ADDENDUM NO. 2

PROJECT: HAGERSTOWN REGIONAL AIRPORT
HANGAR 21 VESTIBULE ADDITION
COUNTY CONTRACT NO. MS-VA-082-18

This **Addendum No. 2** consists of **37 pages**, including this page and all attachments.

Set: 1 – Door 100

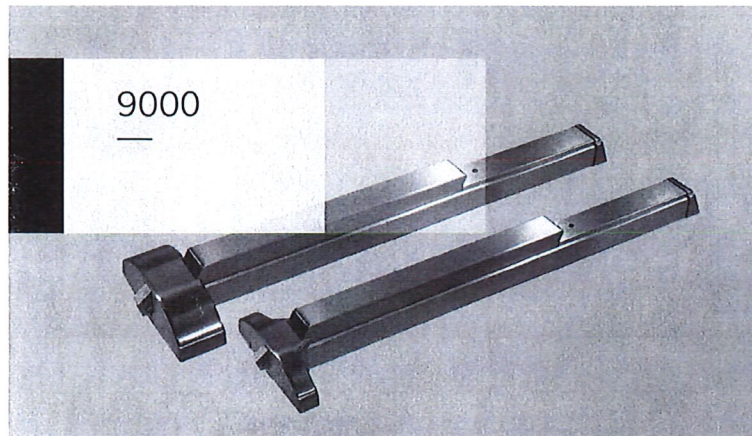
ADD: Hardware Schedule:

- Heavy Duty, Grade-1 DORMA (9000 series) medium stile exit devices, locksets, closers and cylinders shall be provided. See attached product information.
- Hardware finish shall be Stainless Steel (Satin).
- Key system shall match existing keying system.

- 1 Entry Panic Bar Exit Device
- 3 Hinges (Heavy Weight)
- 3 Door Silencers
- 1 Door Stop
- 1 Door Closer

CX-105

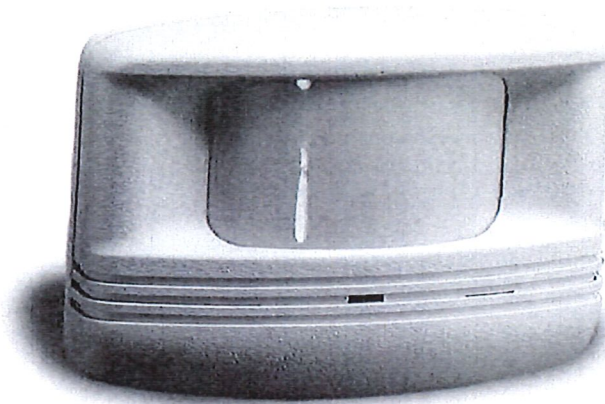
ITEM 2.04 ADD PASSIVE INFRARED OCCUPANCY SENSOR(S); one at top of stairs and one at bottom of stairs. See attached product information. Coordinate installation details with Engineer in field.

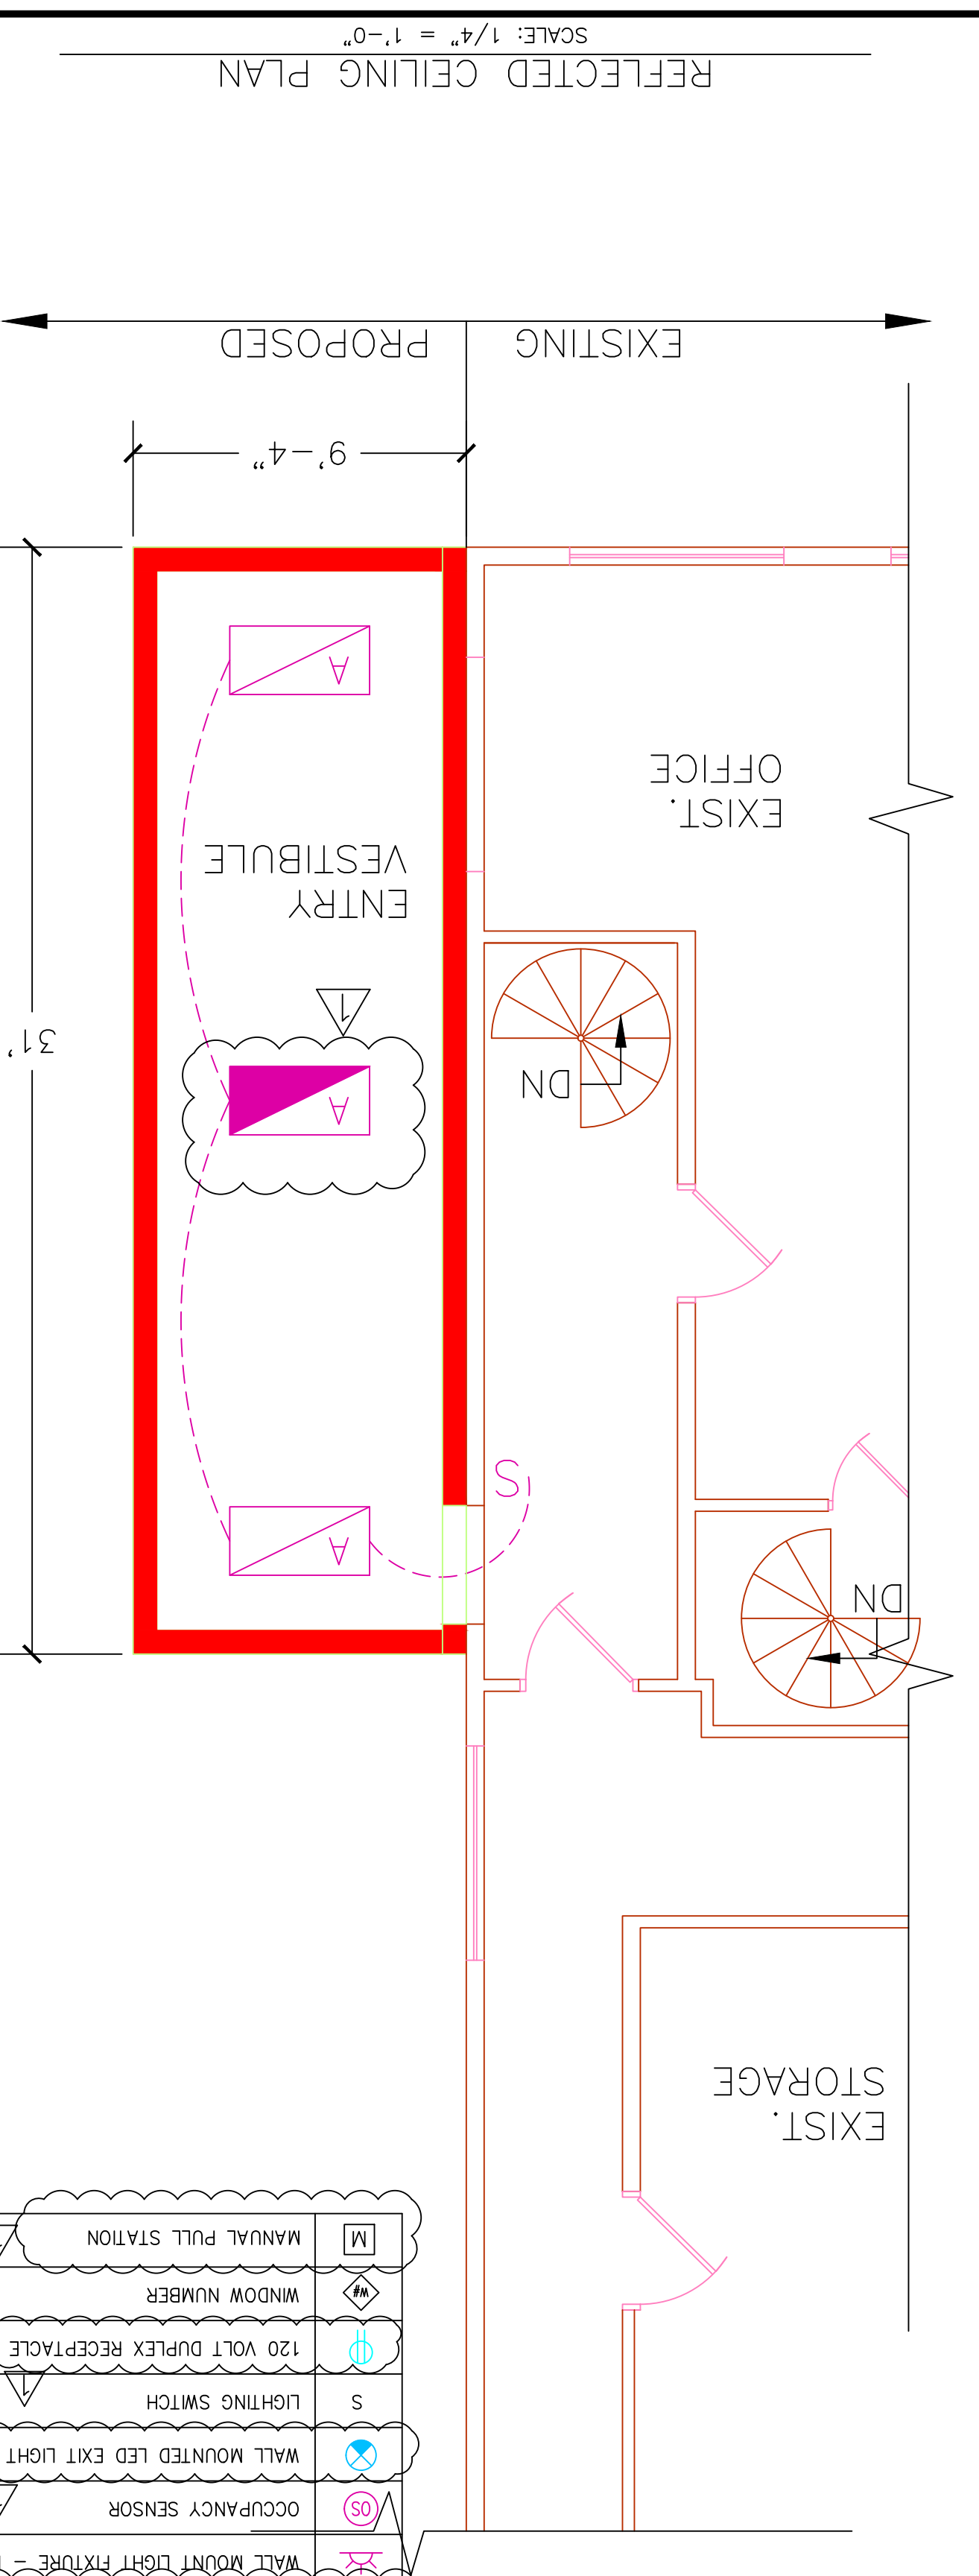
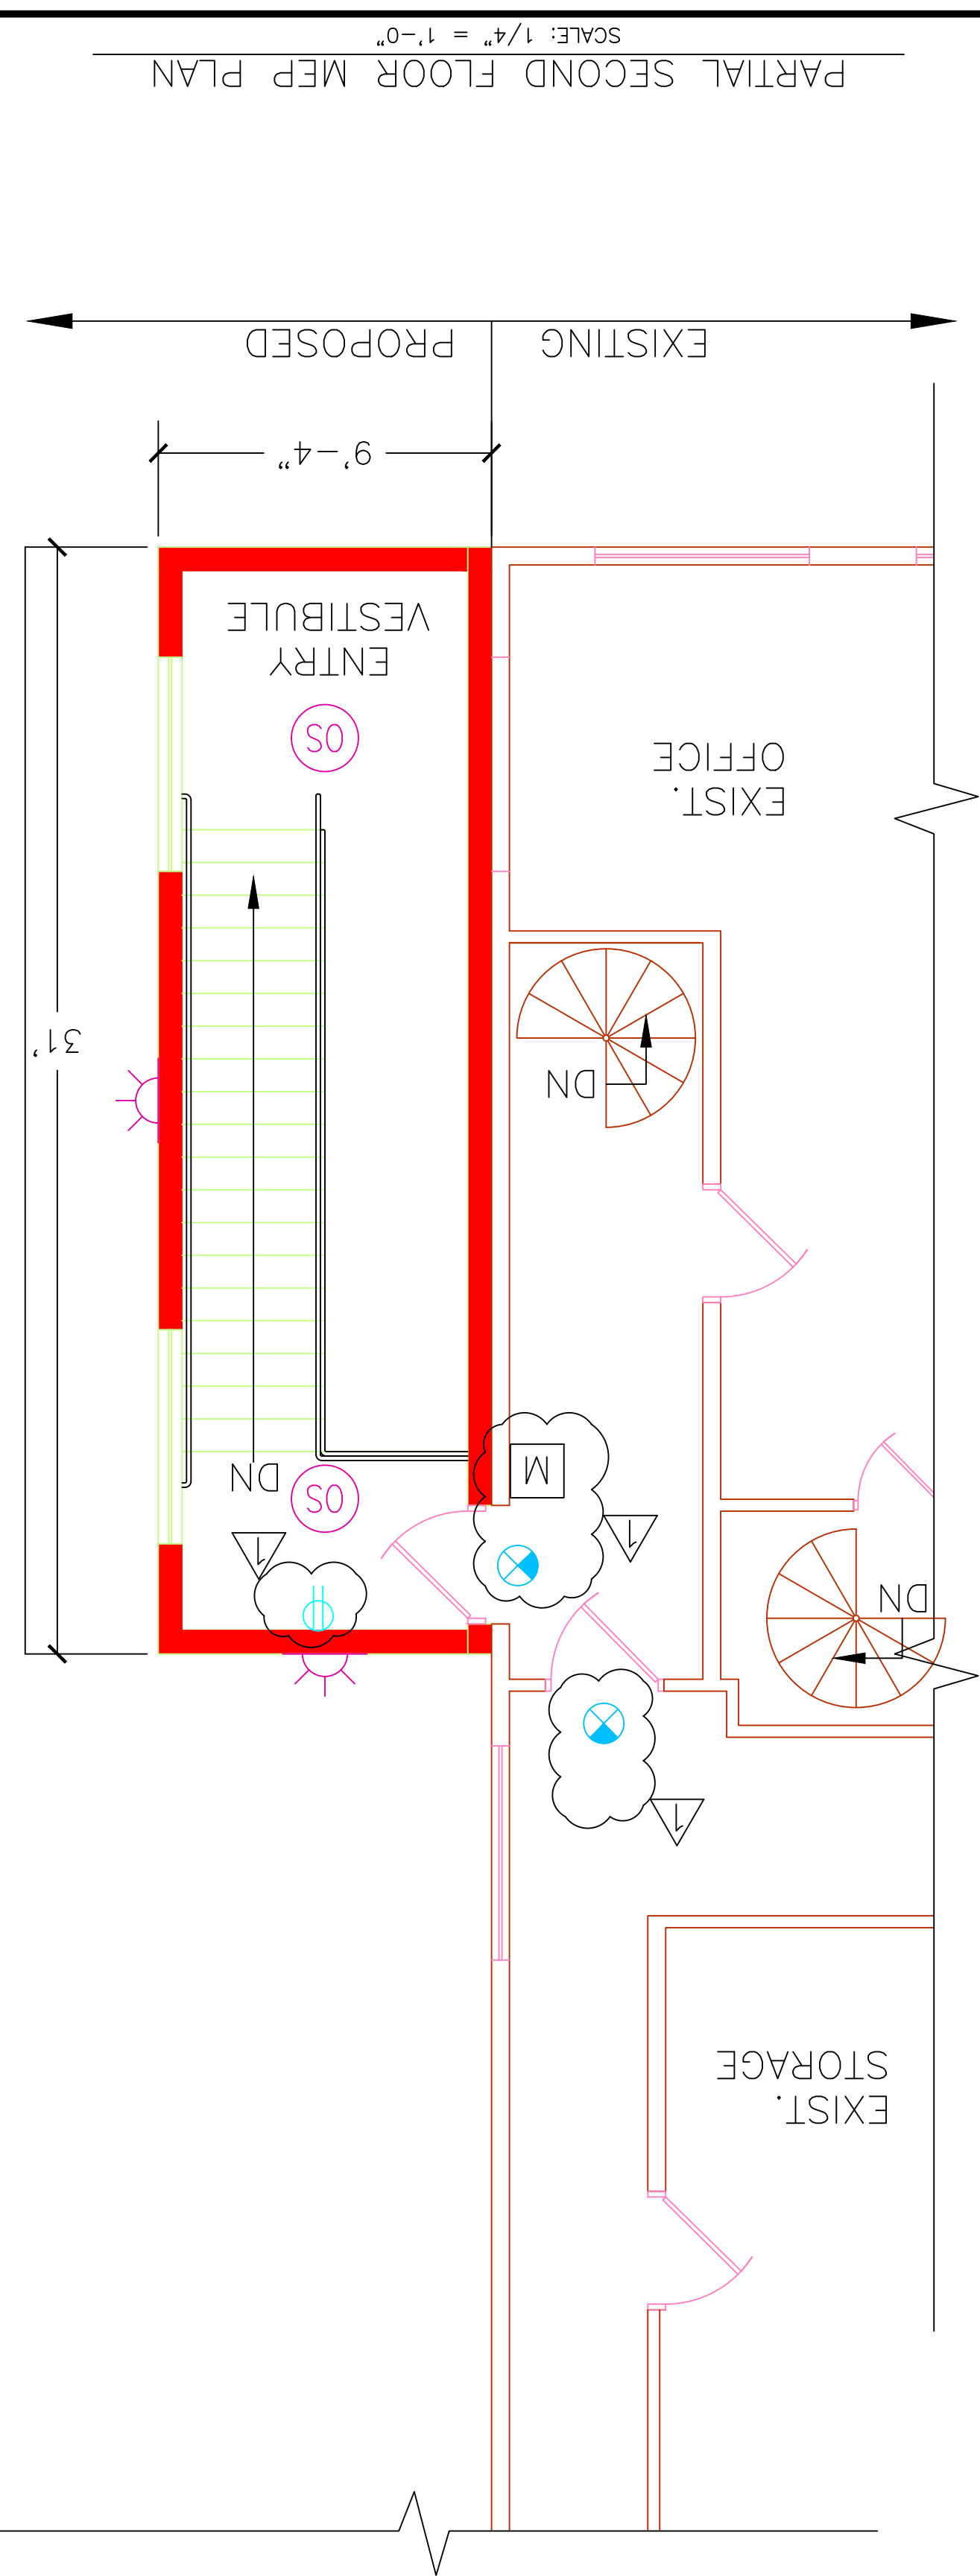
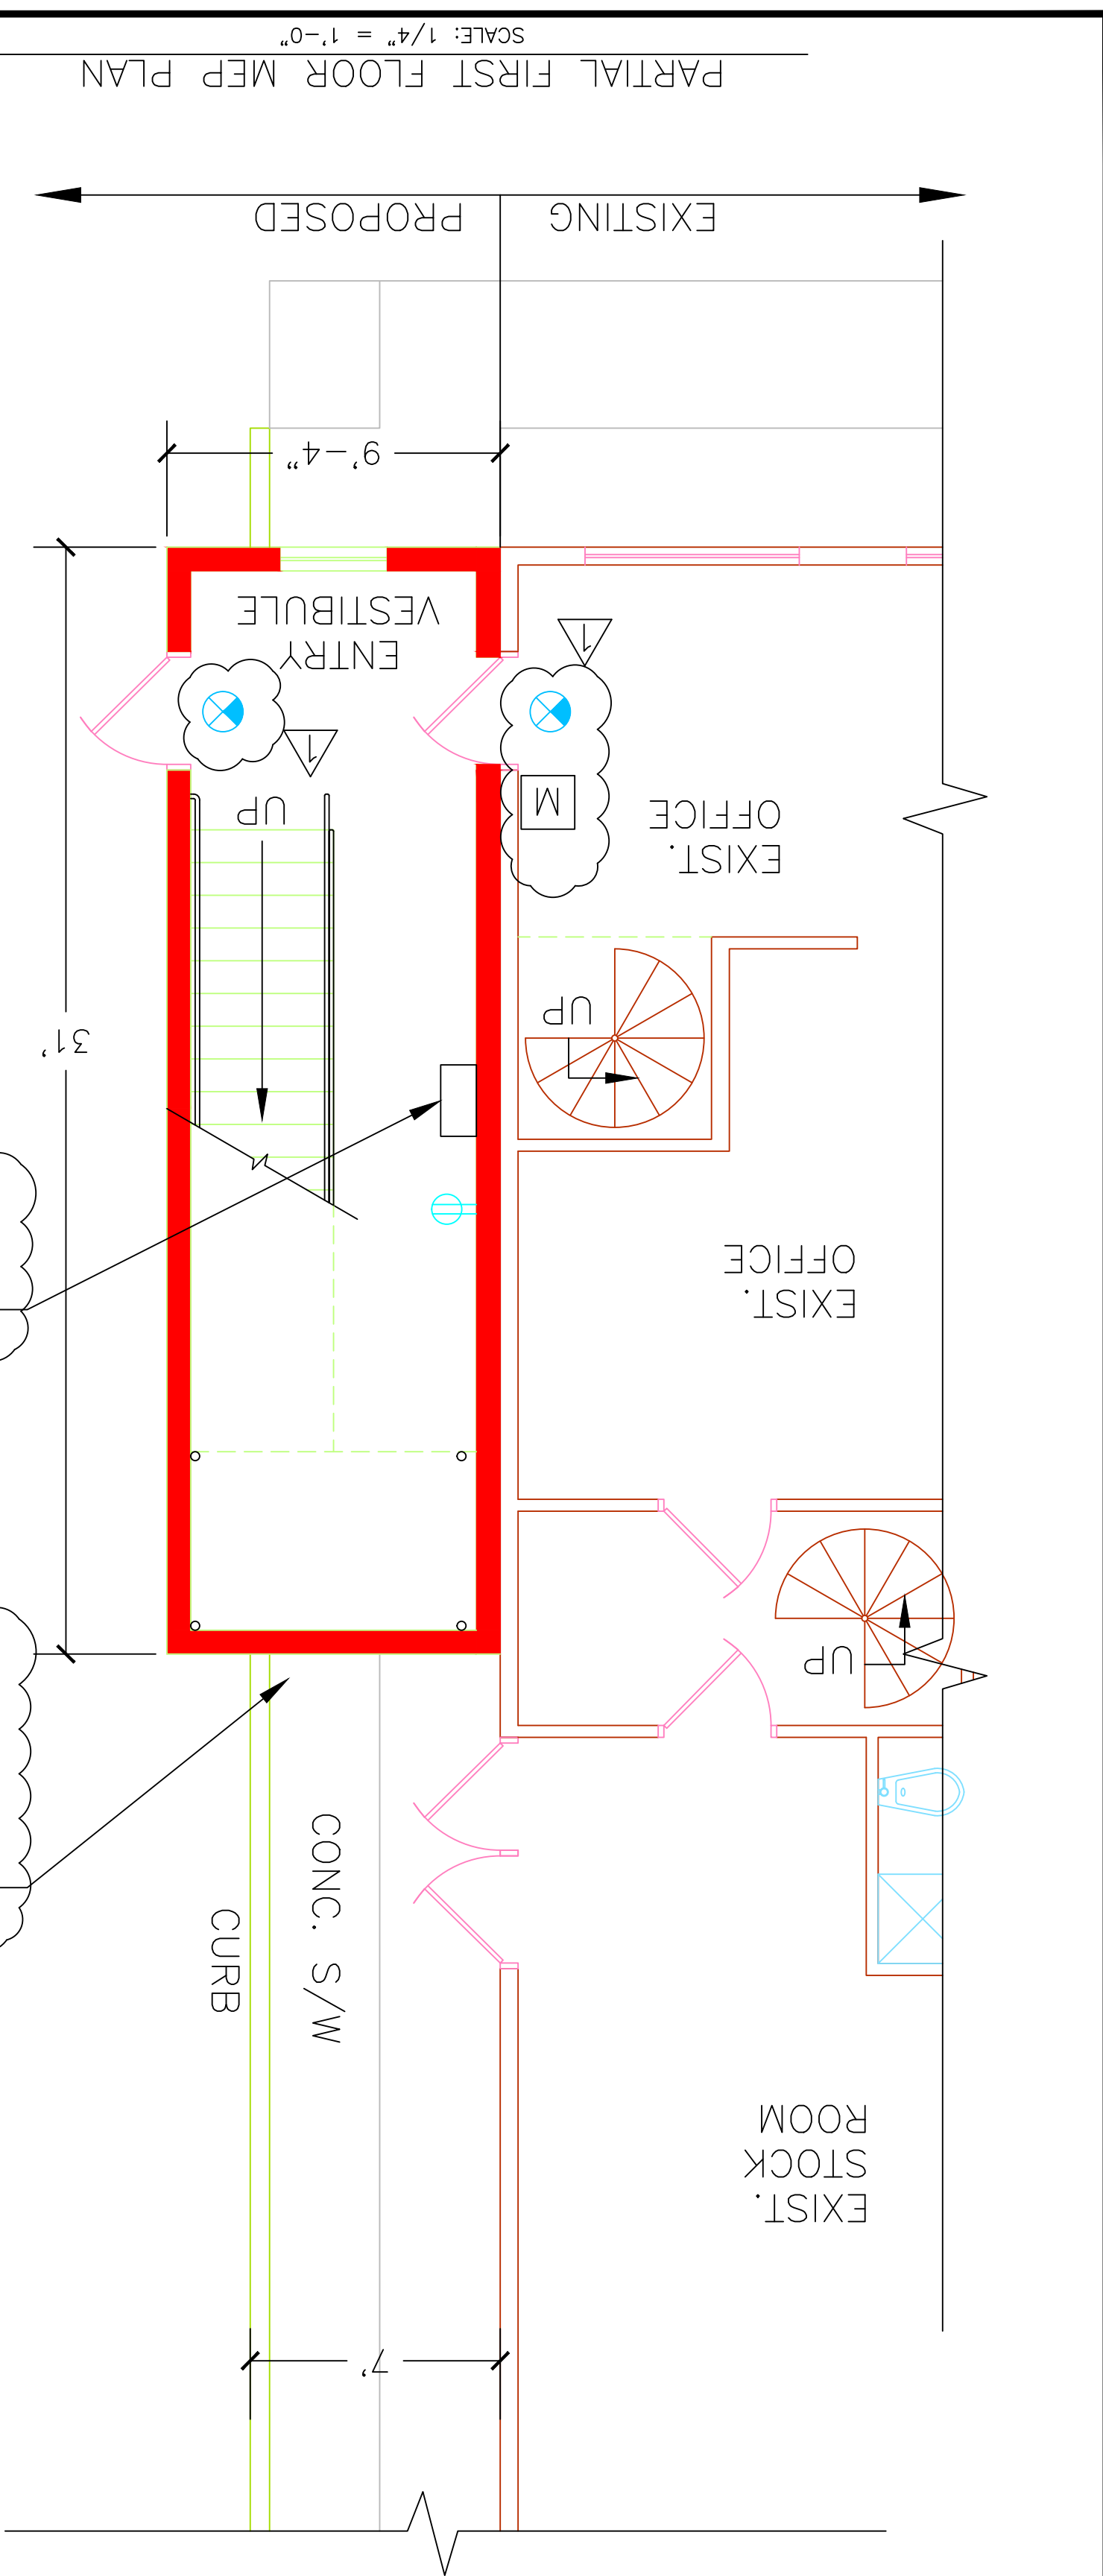
Response: The UHWA heater has been deleted from the project and has been replaced with a wall mounted mini-split heat pump system. The electrical panel is approximately 100 feet away.

Replace Sheet 7 of 8 with Sheet 7 of 8, Rev. 1:

- PARTIAL FIRST FLOOR MEP PLAN
- PARTIAL SECOND FLOOR MEP PLAN
- REFLECTED CEILING PLAN
